14 February 2025

ADDENDUM NO. 3

RE: Chisholm Creek Utility Authority  
Wastewater Treatment Facility Improvements  
WCI File: 20-600-514-00

SHEET NO:  
**A-501**

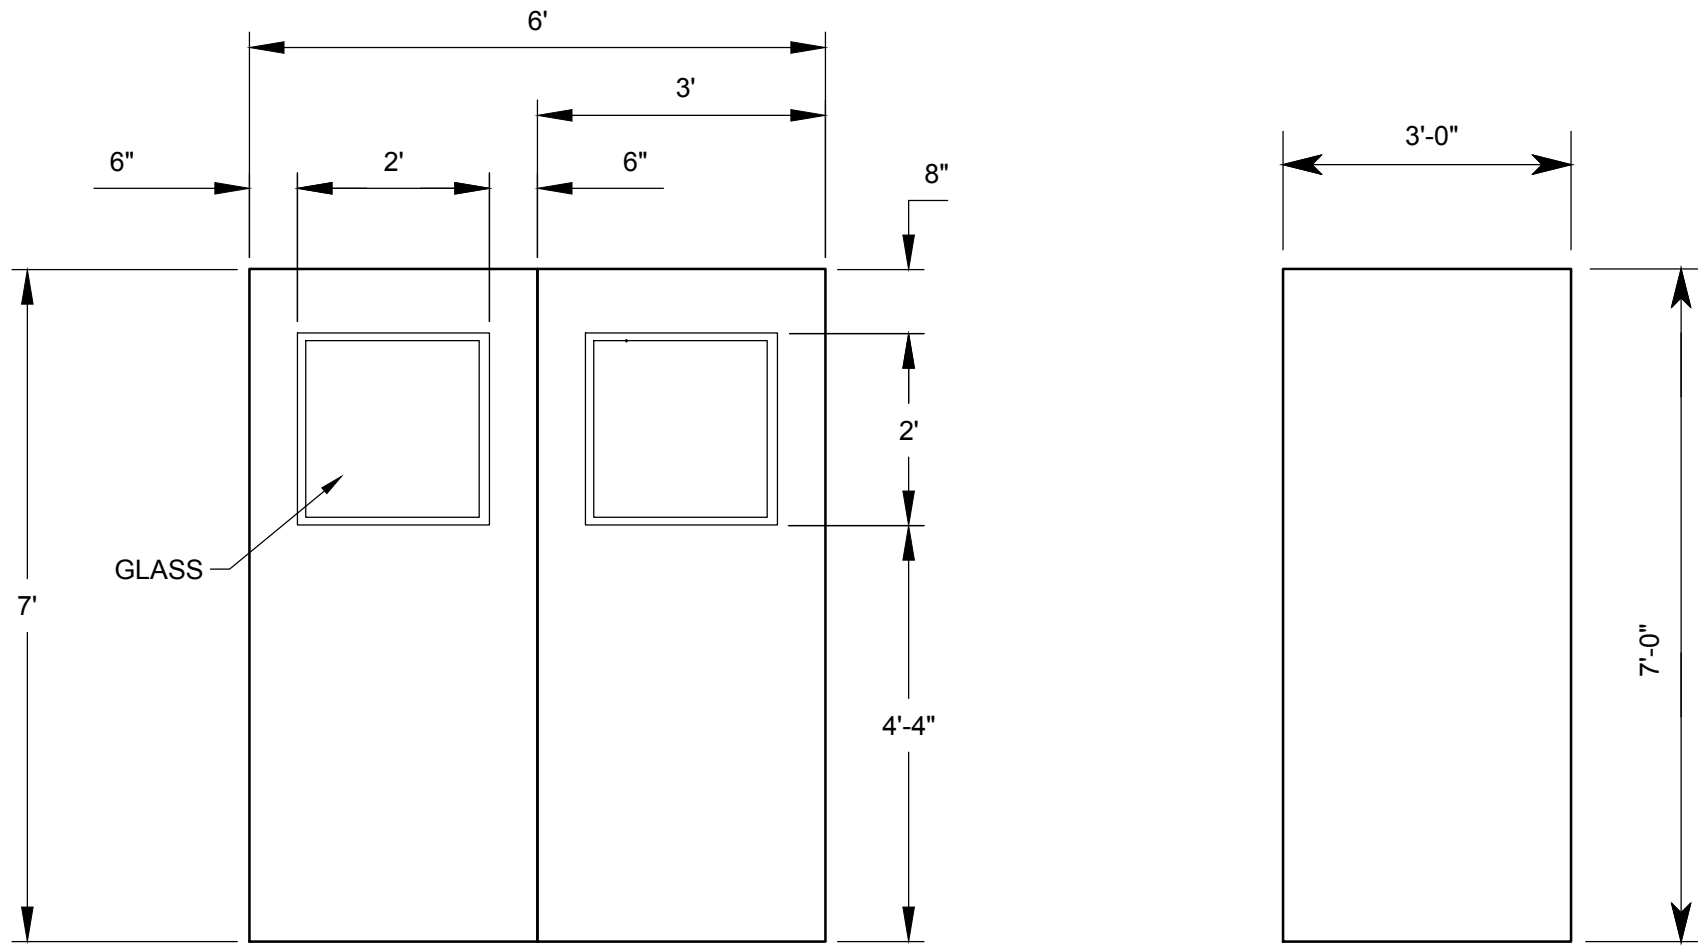
8. Sheet No. A-501  
MODIFICATION of Section View A1 with revised insulation note.
9. Sheet No. A-502  
ADDITION to Door Schedule for Door #106 located at the proposed chemical feed room West of existing SBR Building #3 & #4 (See S-105) .

SHEET NO:  
**G-016**

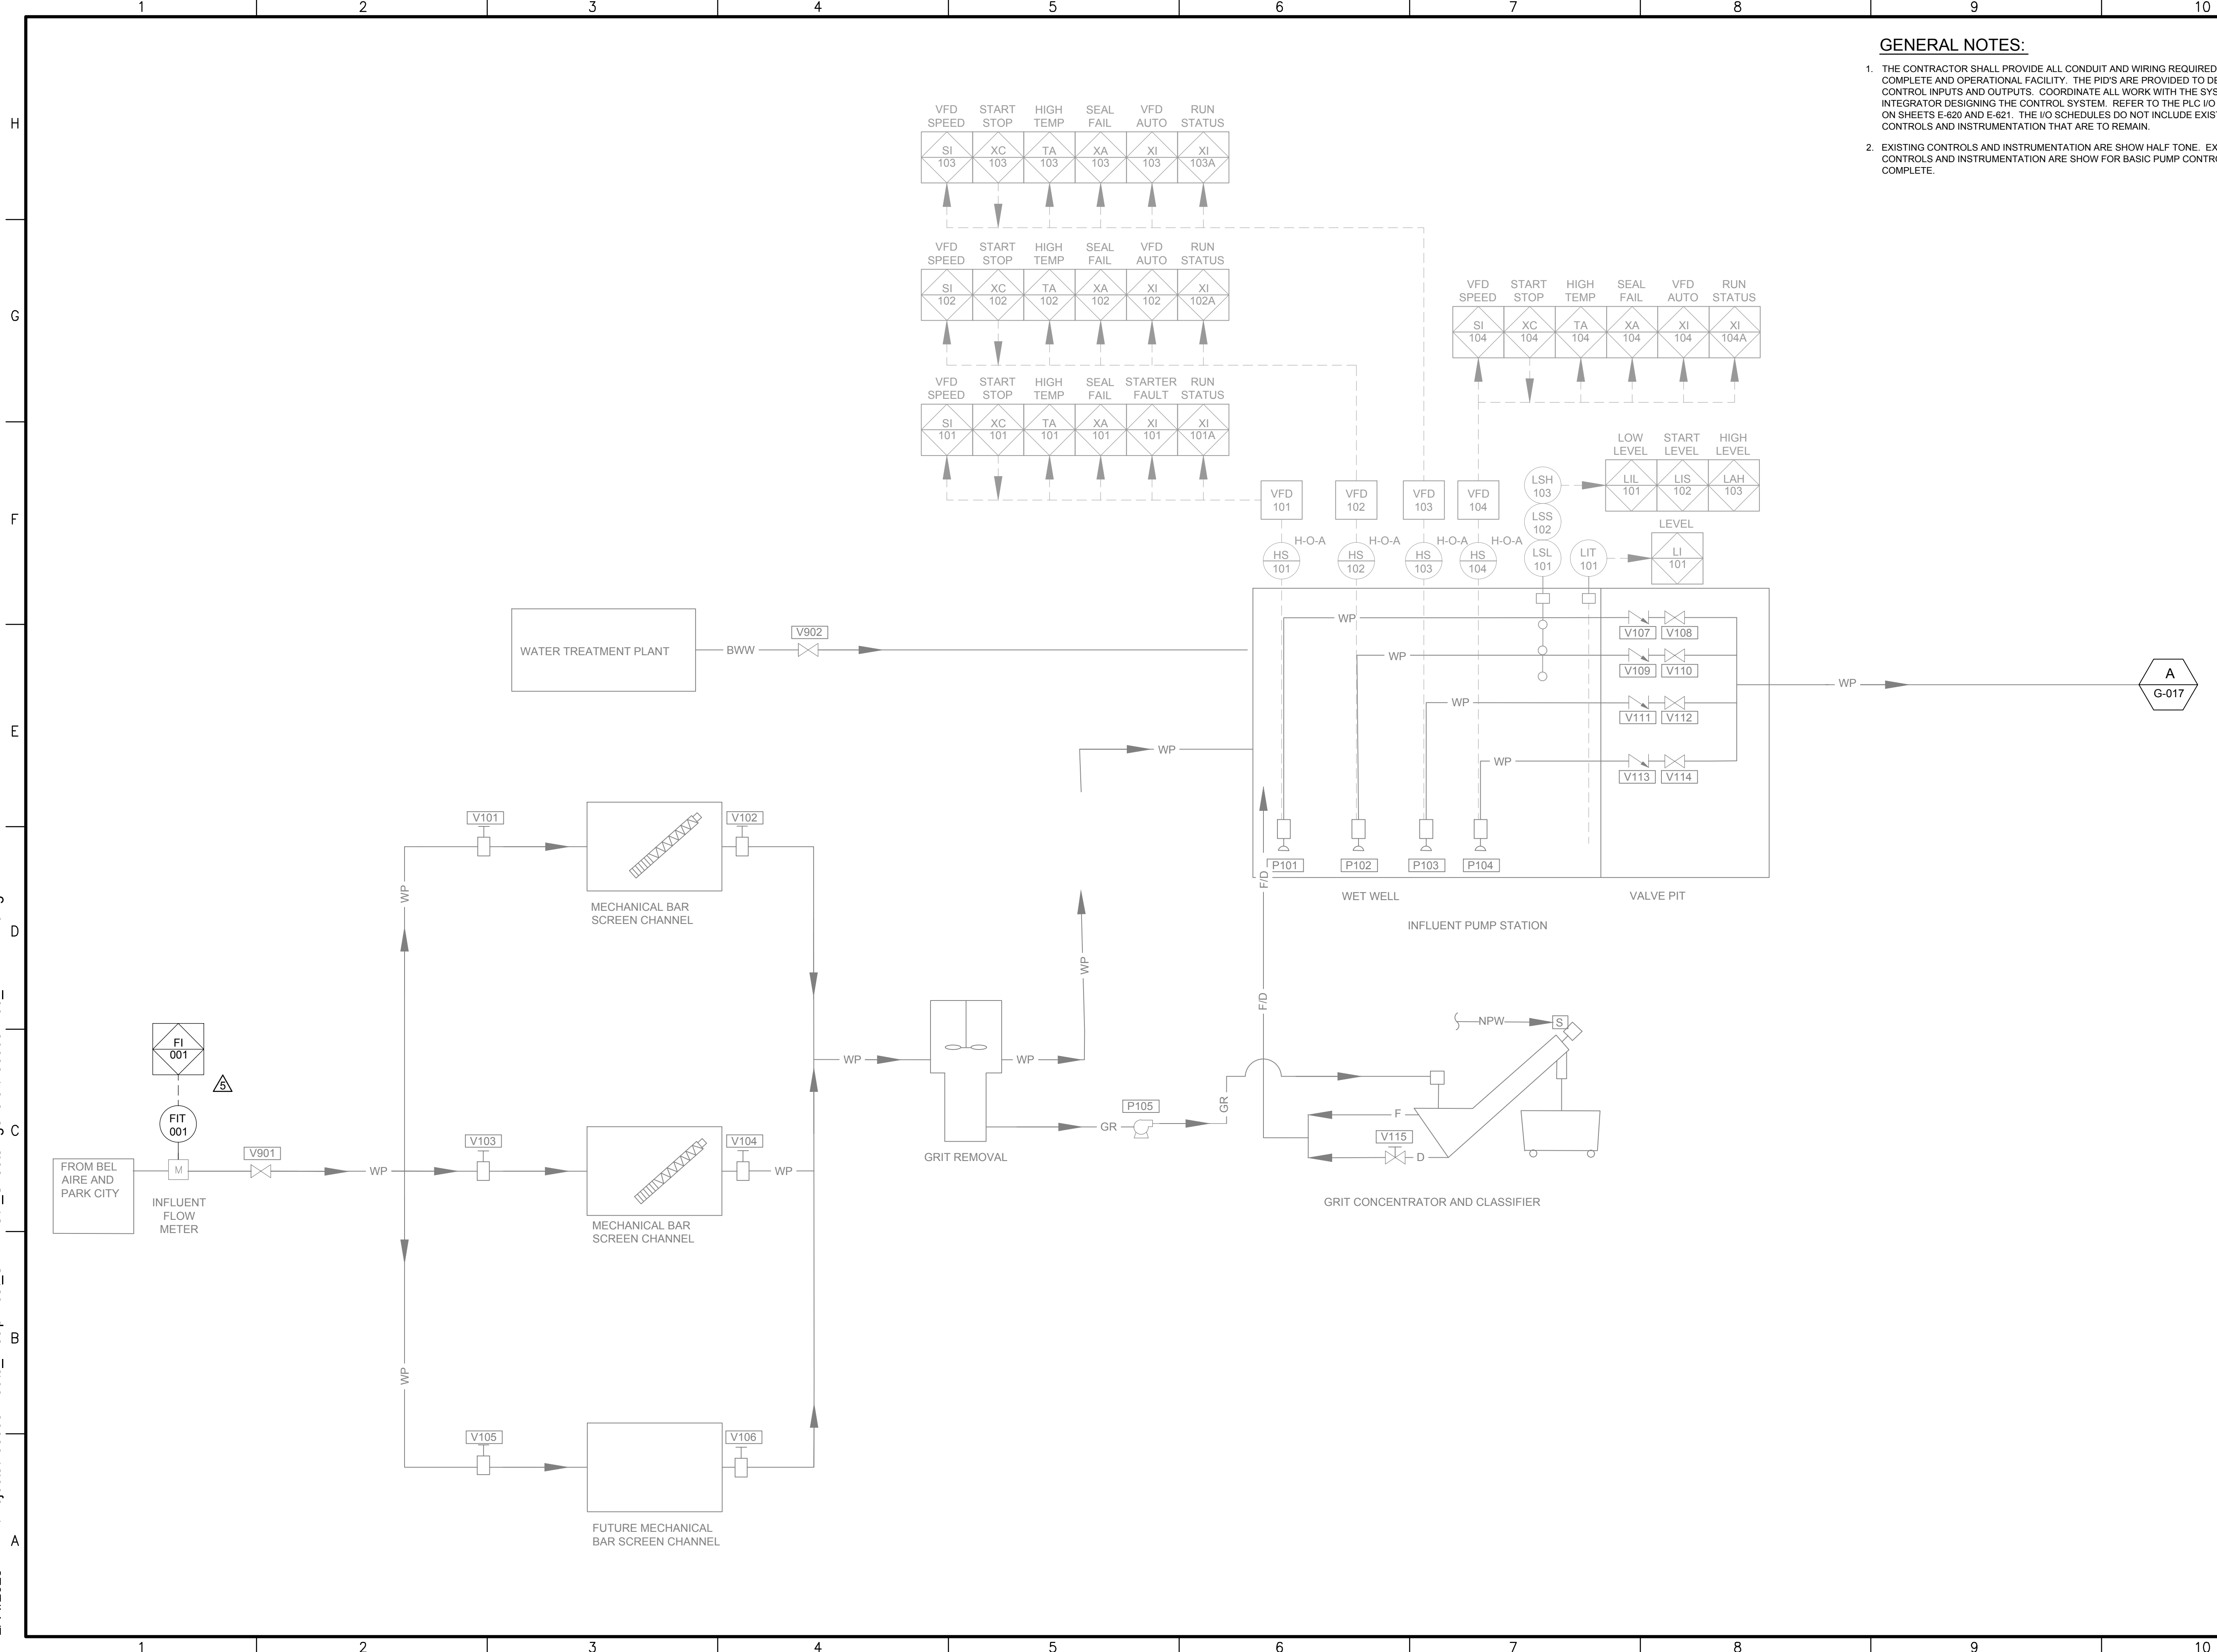
10. Sheet No. G-001  
CLARIFICATION that E-702 contains Belt Filter Press Control Block Diagram.
11. Sheet No. G-016  
ADDITION of influent flow signal to the PLC.
